Department of Infrastructure,  
Local Government and Planning

Our reference: SDA-0416-029516  
Council reference: MCU16/0085

**Concurrence agency response—preliminary approval only (with conditions)**

Proposed development: Preliminary Approval for Material Change of Use – Area  
 Development Application (Harmony Master Planned Area)

**OPM P7 - Area Development Plan (Development & Transport Infrastructure Network Sequencing)**

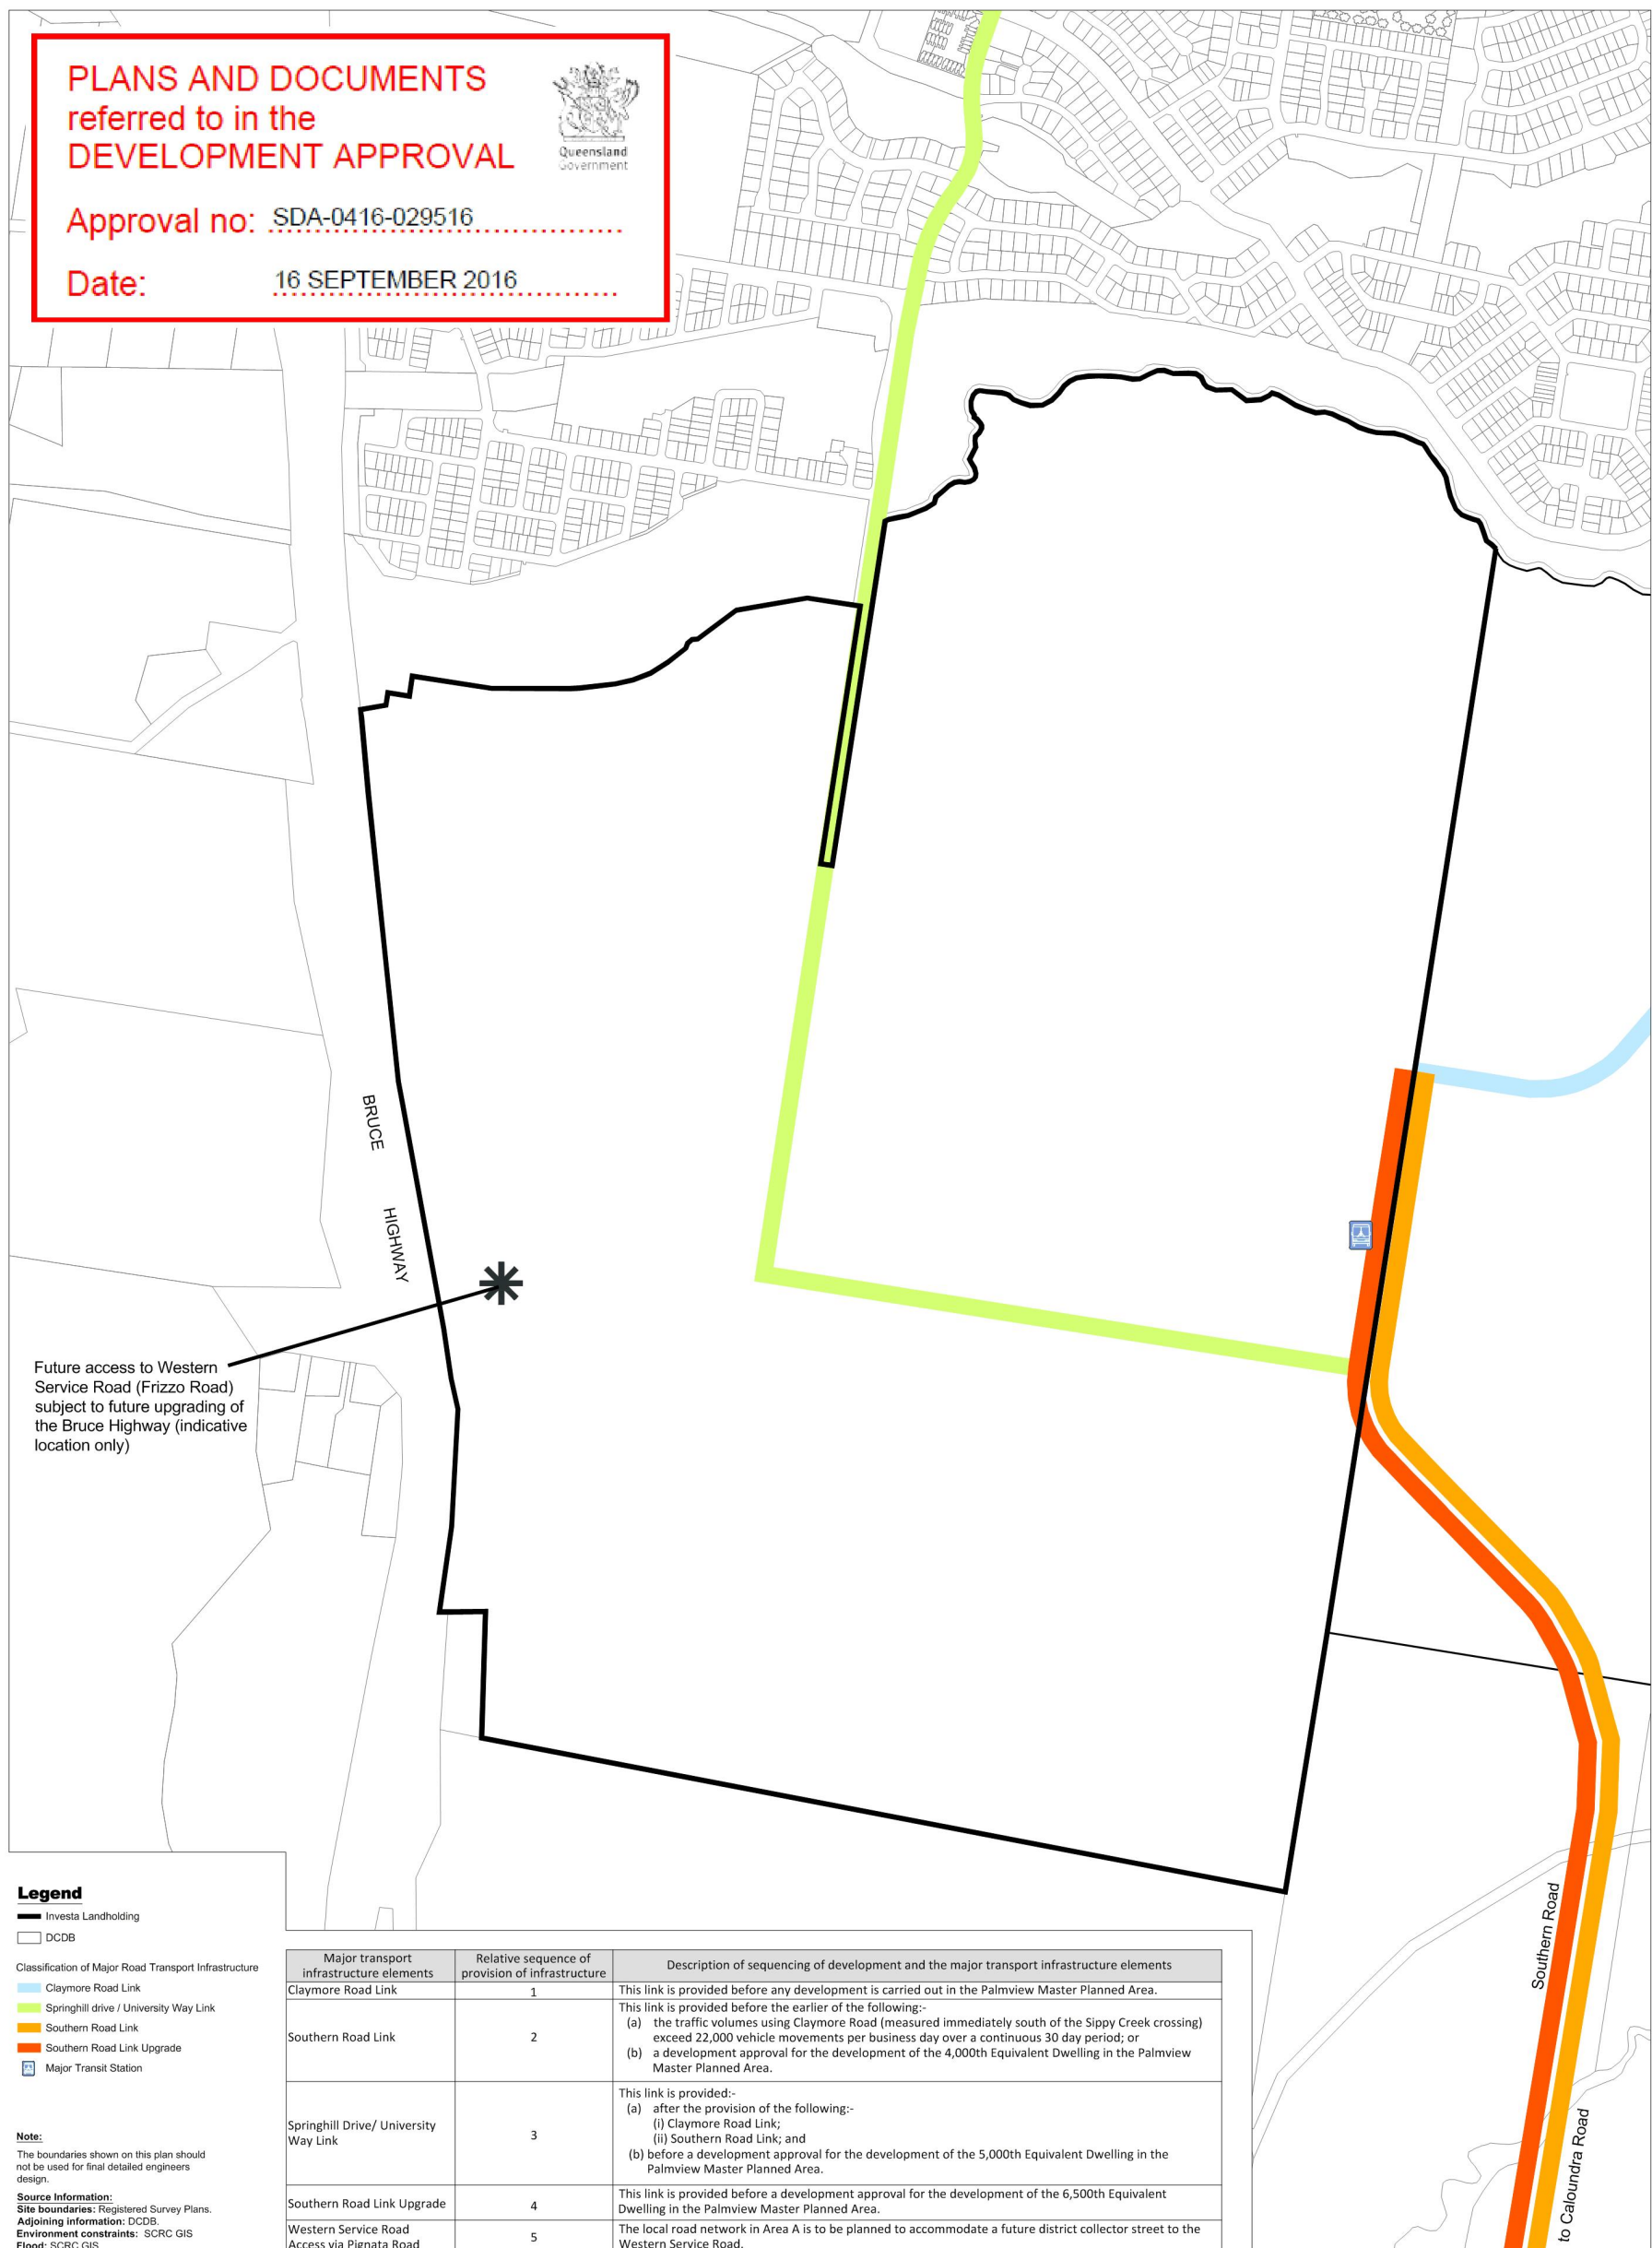
3.	<p>The applicant must amend plan:</p> <p>(a) OPM P7 – Area Development Plan (Development and Transport Infrastructure Network Sequencing) prepared by RPS dated March 2016, reference</p>

No.	Conditions	Condition timing
	22470-282C to reflect the approach detailed in Condition 2; and (b) The applicant must provide a copy of the amended plan to the Department of Infrastructure, Local Government and Planning.	
<b>Managing Noise Impacts</b>

Road Hierarchy Plan: Potential Future Bus Routes: Amended by DTMR 21 June 2016 (Revision A)

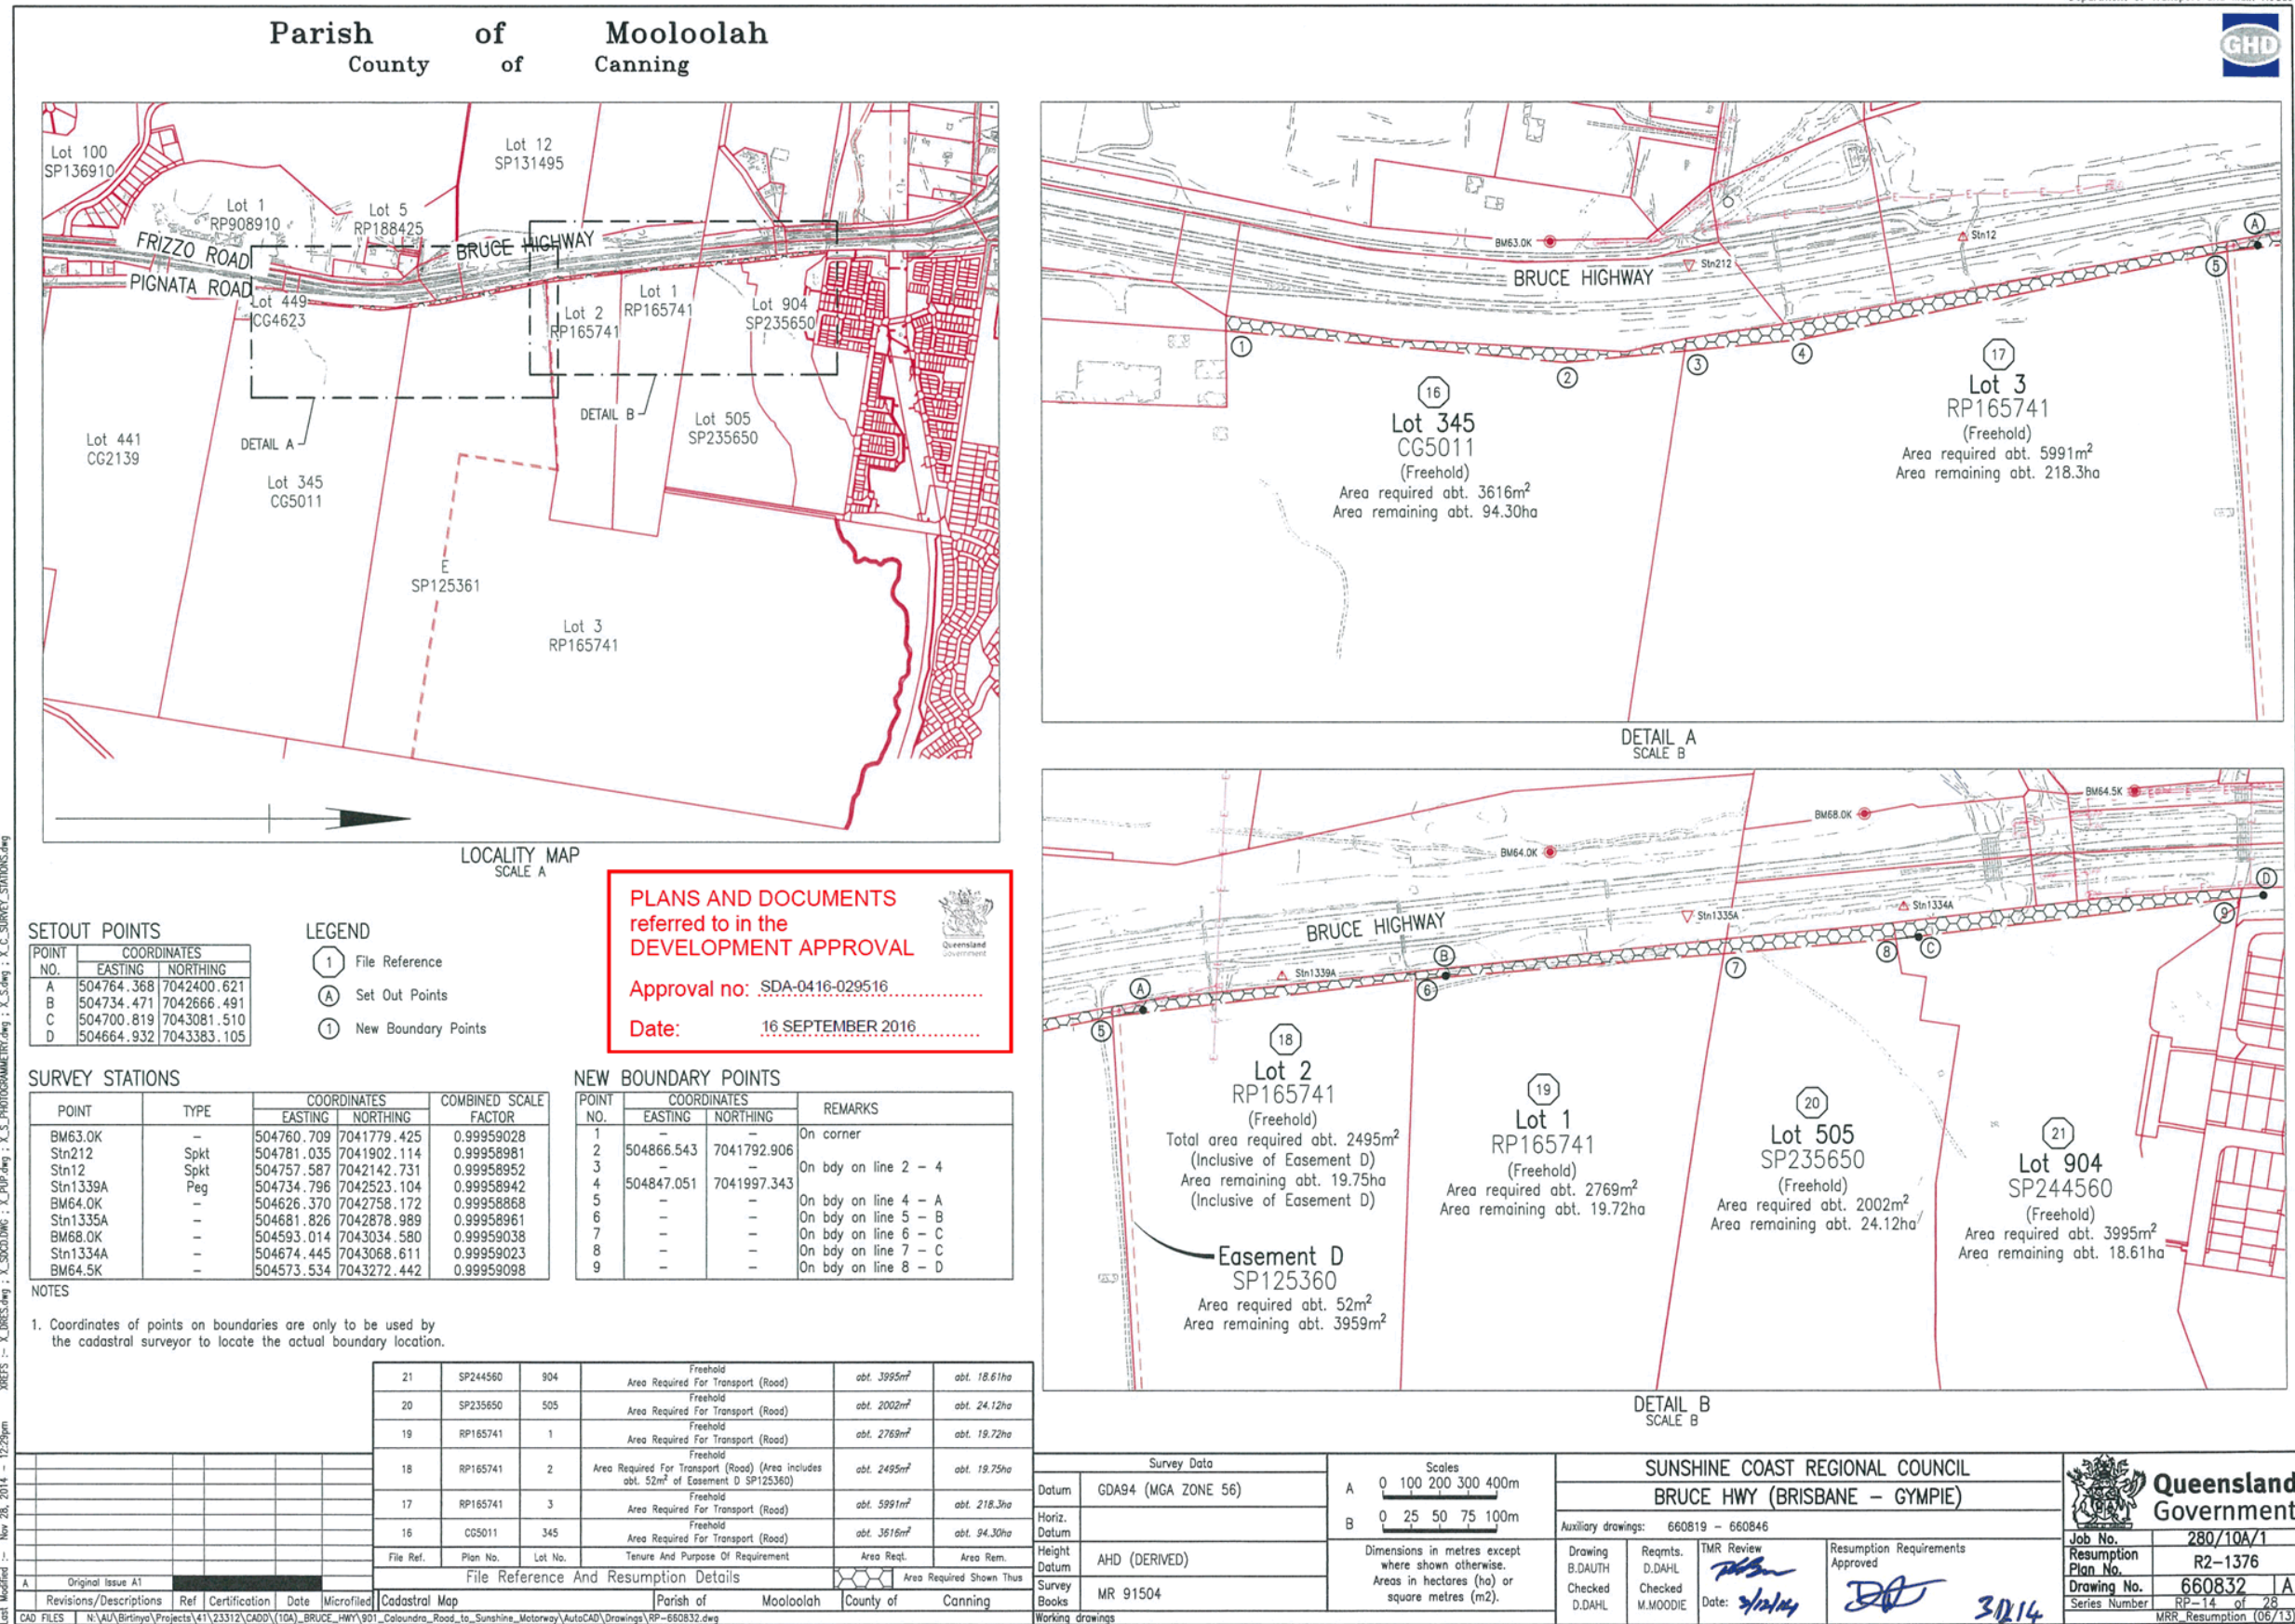
6.	<ul style="list-style-type: none"> <li>(a) The roads shown as 'Potential future bus routes' on the Road Hierarchy Plan: Potential Future Bus Routes, as amended in red by DTMR, dated 21 June 2016, must be designed and constructed by the applicant to be in accordance with the Schedule – Code for IDAS, Part 2 – Development Standards of the <i>Transport Planning and Coordination Regulation 2005</i> to accommodate a single unit rigid bus of 12.5m in length.</li> <li>(b) Traffic calming devices should not be incorporated into the design and construction of potential future bus routes in accordance with Chapter 2 - Planning and Design, section 2.3.2 - Bus Route Infrastructure (page 6) of the Department of Transport and Main Roads' TransLink Public Transport Infrastructure Manual 2015. The Public Transport Infrastructure Manual 2015 is available at: <a href="http://translink.com.au/about-translink/reports-and-publications">http://translink.com.au/about-translink/reports-and-publications</a>.</li> </ul>	Prior to submitting the Plan of Survey to the local government for approval for the relevant stage, or prior to the commencement of use for the relevant stage, whichever occurs first.
